TVA-BFN-TS-441R1

BROWNS FERRY NUCLEAR PLANT (BFN) - UNITS 2 and 3 - TECHNICAL SPECIFICATIONS (TS) CHANGE TS-441 REVISION 1 - UPDATE OF PRESSURE-TEMPERATURE (P-T) CURVES

PROPOSED TECHNICAL SPECIFICATIONS (TS) CHANGE TS-441R1 TVA EVALUATION OF PROPOSED CHANGE

**PROPOSED TECHNICAL SPECIFICATIONS (TS) CHANGE TS-441R1
MARKED PAGES**

Figure 3.4.9-1
Pressure/Temperature Limits

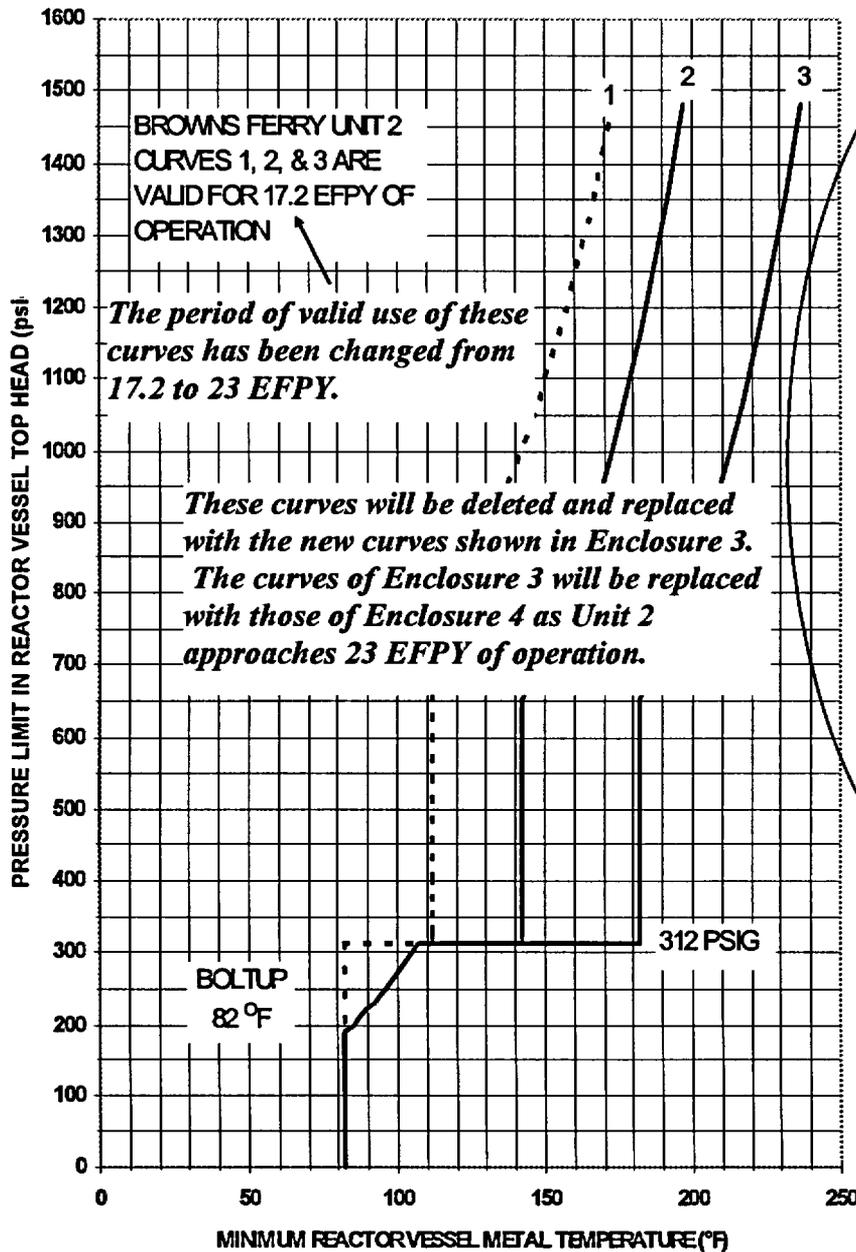
Curve Legends have been revised on new TS pages to include the additional curves, their applicability, and the new Unit 2 valid EFPY interval of 23 years

Notes
These curves include sufficient margin to provide protection against feedwater nozzle degradation. The curves allow for shifts in RT_{NDT} of the Reactor vessel beltline materials, in accordance with Reg. Guide 1.99, Rev. 2, to compensate for radiation embrittlement for 17.2 EFPY.

**Figure 3.4.9-1
Pressure/Temperature Limits**

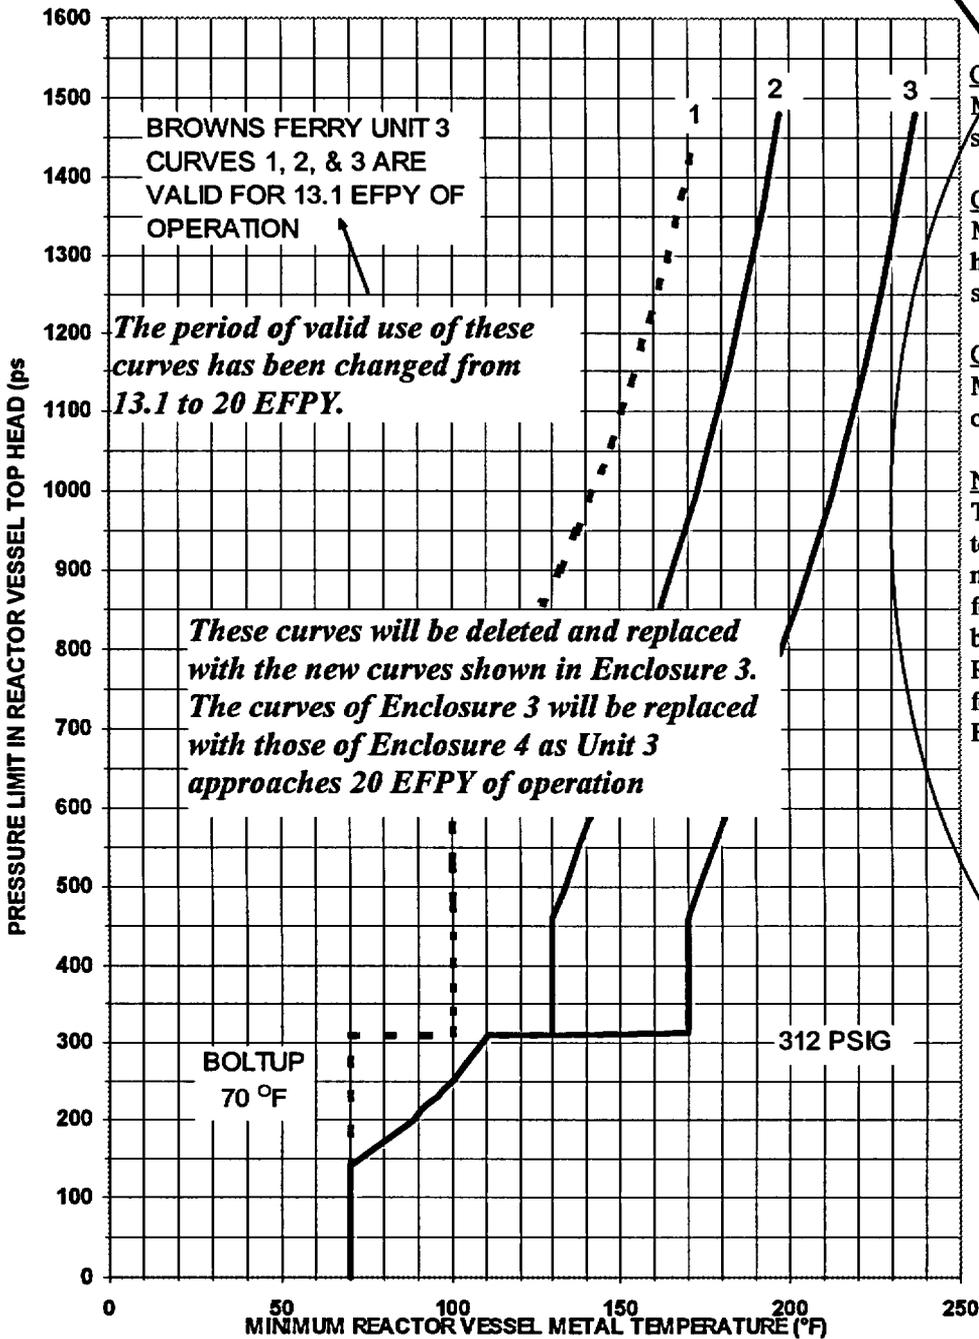
Curve Legends have been revised on new TS pages to include the additional curves, their applicability, and the new Unit 3 valid EFPY interval of 20 years

Notes
These curves include sufficient margin
to provide protection against feedwater
nozzle degradation. The curves allow
for shifts in RT_{NDT} of the Reactor vessel
beltline materials, in accordance with
Reg. Guide 1.99, Rev. 2, to compensate
for radiation embrittlement for 13.1
EFPY.

Figure 3.4.9-1
Pressure/Temperature Limits for
Mechanical Heatup, Cooldown following Shutdown, and
Reactor Critical Operations

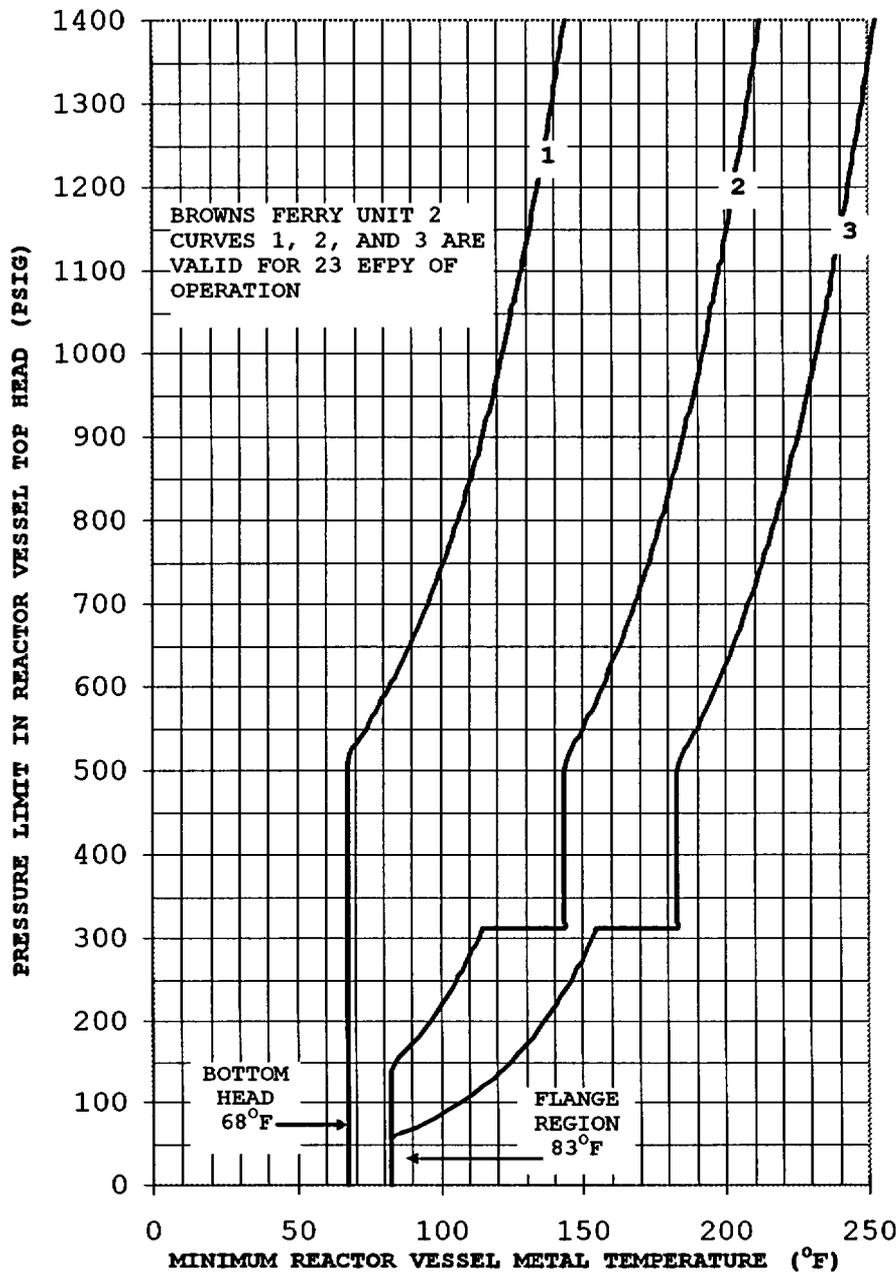
2. The new TS Figure 3.4.9-1 contains an added curve which specifically details reactor vessel bottom head temperature versus pressure limitations for non-critical heatup/cooldown operational conditions.
3. A new TS Figure 3.4.9-2 has been added which contains curves for the reactor vessel bottom head and the upper vessel/beltline regions for in-service leak and hydrostatic testing activities.
4. The legend information on these TS figures has been revised to appropriately describe the additional curves and their usage.
5. References to these figures within the TS body have been revised as necessary to appropriately reflect their use.

Curve No. 1
Minimum temperature for bottom head during mechanical heatup or cooldown following nuclear shutdown.

Curve No. 2
Minimum temperature for upper RPV and beltline during mechanical heatup or cooldown following nuclear shutdown.

Curve No. 3
Minimum temperature for core operation (criticality).

Notes
These curves include sufficient margin to provide protection against feedwater nozzle degradation. The curves allow for shifts in RT_{NDT} of the Reactor vessel beltline materials, in accordance with Reg. Guide 1.99, Rev. 2, to compensate for radiation embrittlement for 23 EFPY.
